Addendum

Document Affected: WM1000/WM2000 User Instructions, Publication Number 9350-7621-000 Rev. B

Addendum Number: 1

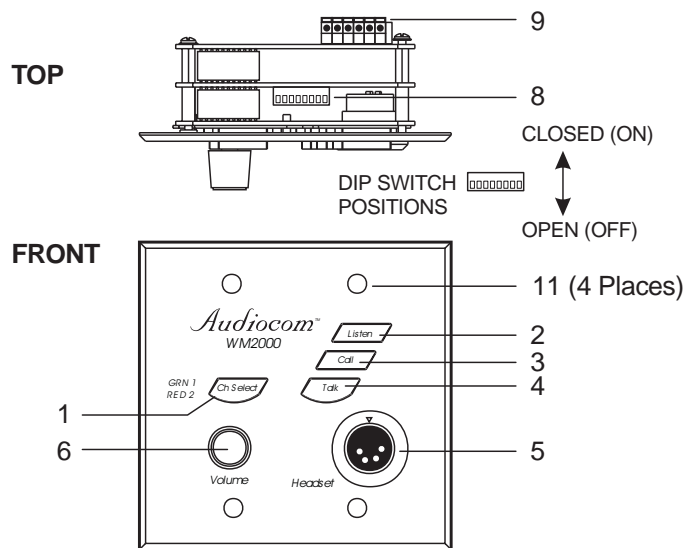
When setting the DIP switches, it is difficult to identify the open and closed positions. The open and closed positions are shown below.
